**SPECIAL PROVISIONS  
FOR  
MULTI-COMPONENT LIQUID PAVEMENT MARKINGS**

**Cass County  
IMX-080-1(508)50--02-15**

**Effective Date  
December 21, 2021**

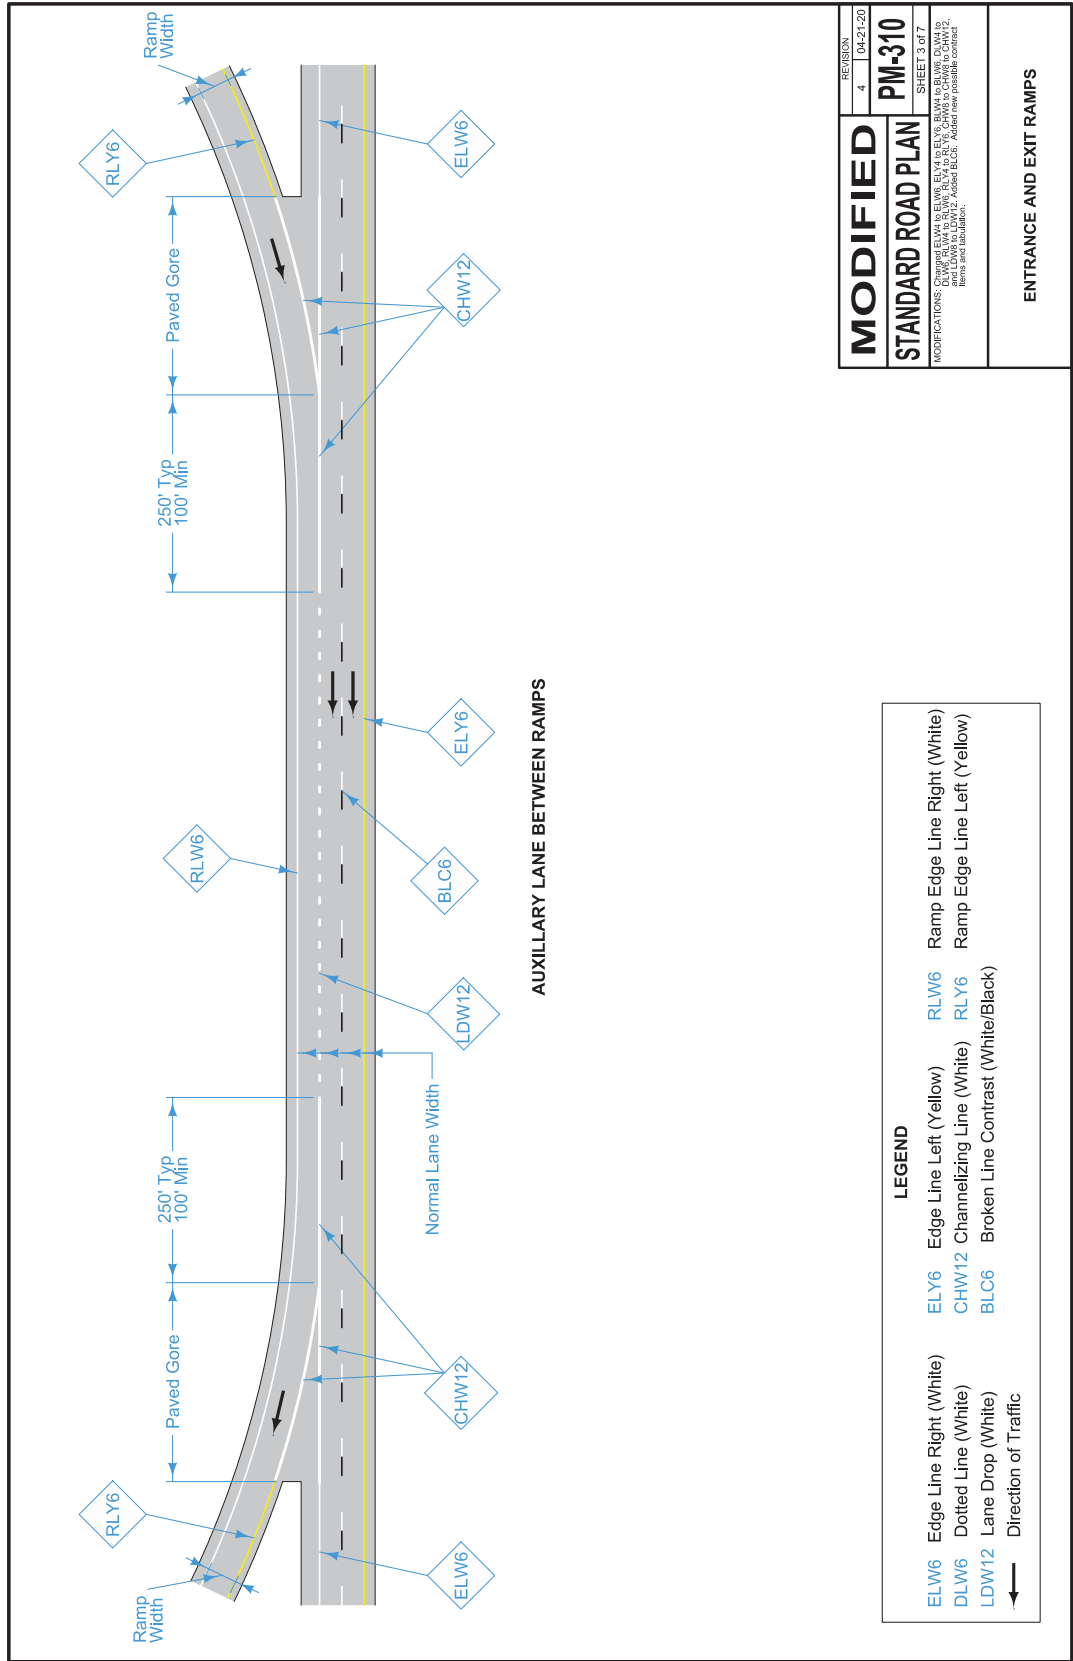
REVISION	4	04-27-20
<b>MODIFIED</b>	<b>PM-310</b>	SHEET 2 of 7
<small>STANDARD ROAD PLAN</small> <small>MODIFICATIONS: Changed ELW6 to ELY6, ELW6 to ELY6, BLM6 to ELW6, DMW6 to DLW6, RLY6 to RLV6, RLY6 to RLV6, CHW12 to CHW12, BLC6 to BLC6, added BLC6, Added new private contract items and fabrication.</small>		
<b>ENTRANCE AND EXIT RAMPS</b>

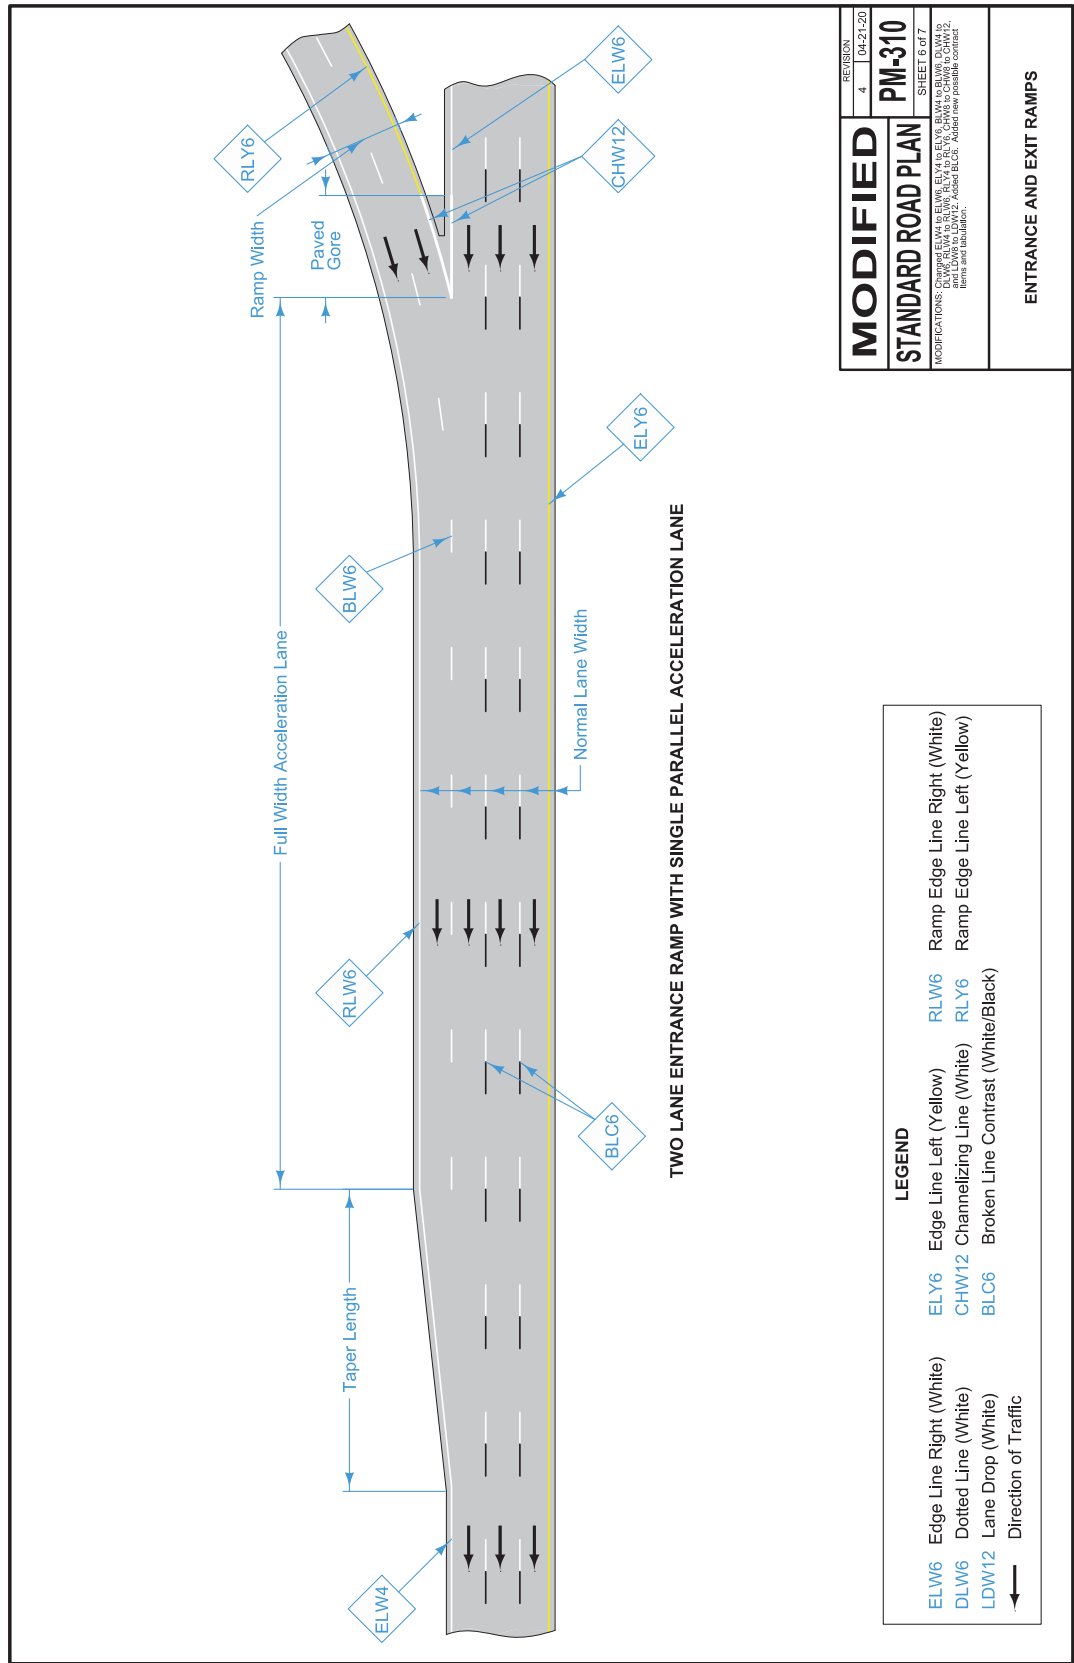
**MODIFIED**  
**STANDARD ROAD PLAN**  
 SHEET 5 of 7  
 PM-310  
 REVISION: 4 04-27-20  
 MODIFICATIONS: Changed ELW6 to ELY6, ELW6 to ELY6, BLW6 to BLY6, DLW6 to DLW6, RLY6 to RLY6, BLY6 to BLY6, CHW12 to CHW12, Lane Drop (White) to Lane Drop (White/Black). Added new parallel contract items and fabrication.  
**ENTRANCE AND EXIT RAMP**

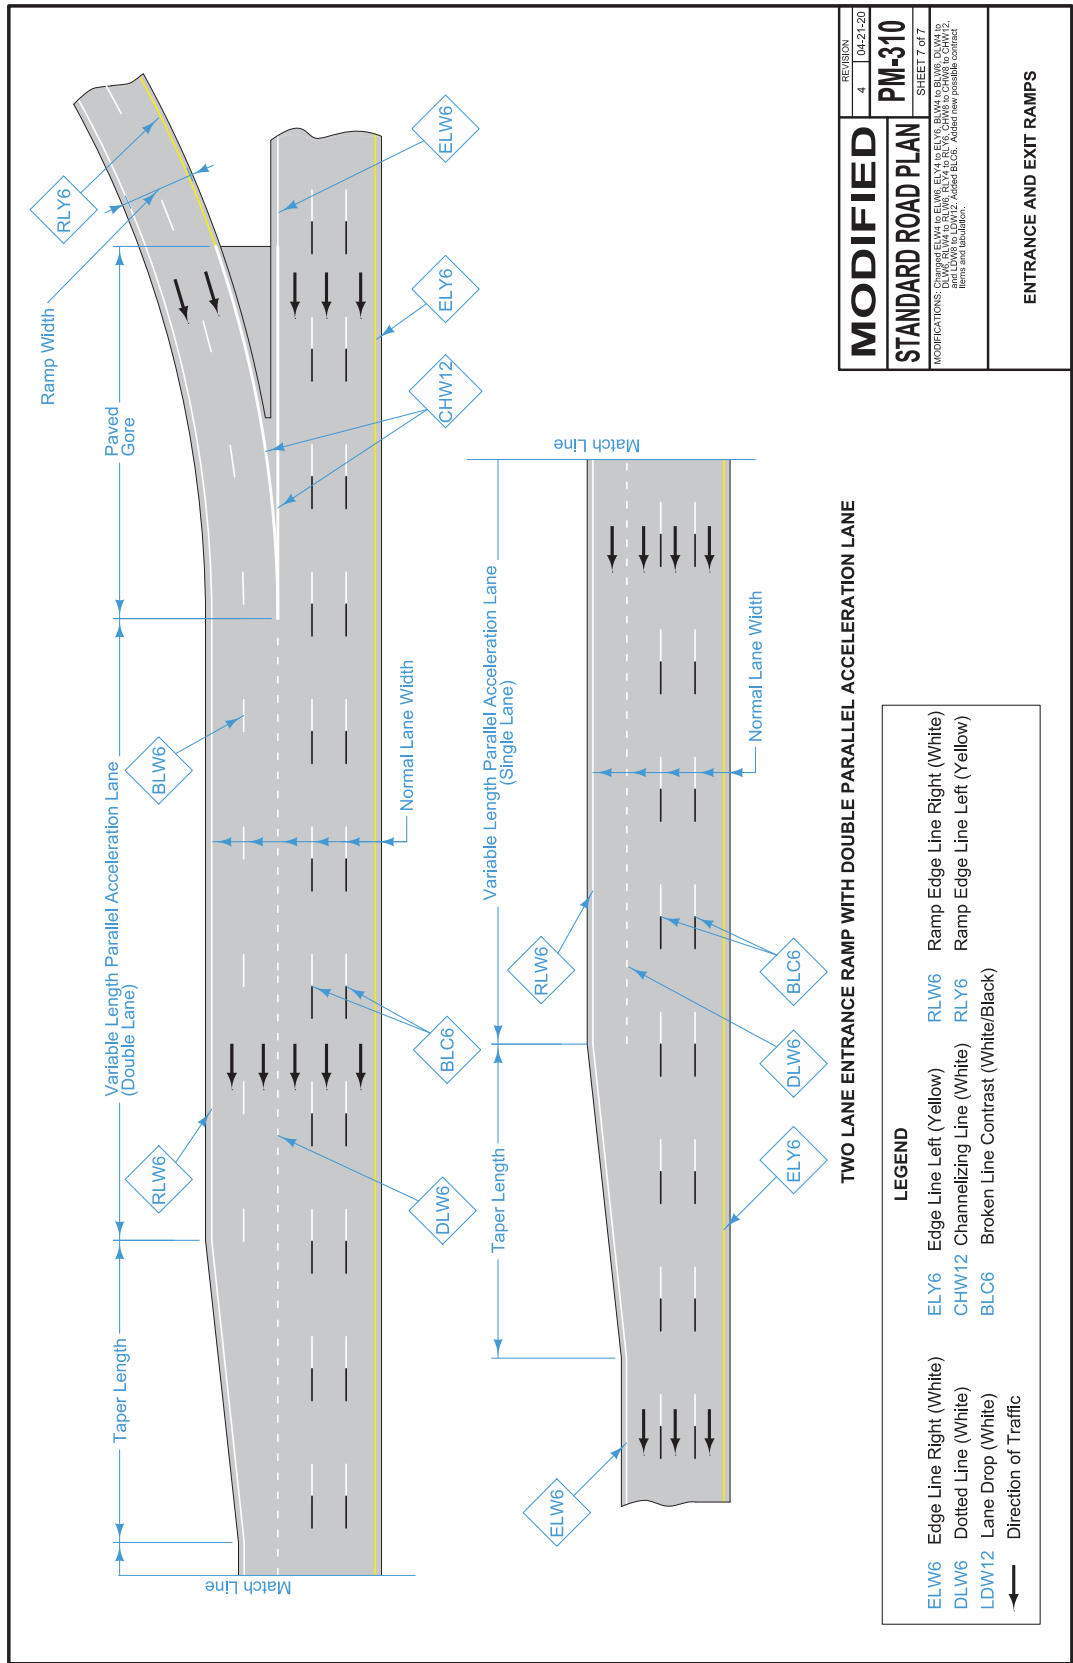
<b>MODIFIED</b>	REVISION	4	04-27-20
	<b>PM-310</b>		
<b>STANDARD ROAD PLAN</b>		SHEET 6 of 7	
<small>MODIFICATIONS: Changed ELW6 to ELW6, ELW4 to ELW6, BLW6 to BLW6, DLW6 to DLW6, RLY6 to RLY6, CHW12 to CHW12, LANE WIDTHS to LANE WIDTHS, ADDED NEW PAVEMENT CONTRACT ITEMS AND FABRICATOR.</small>			
<b>ENTRANCE AND EXIT RAMP</b>
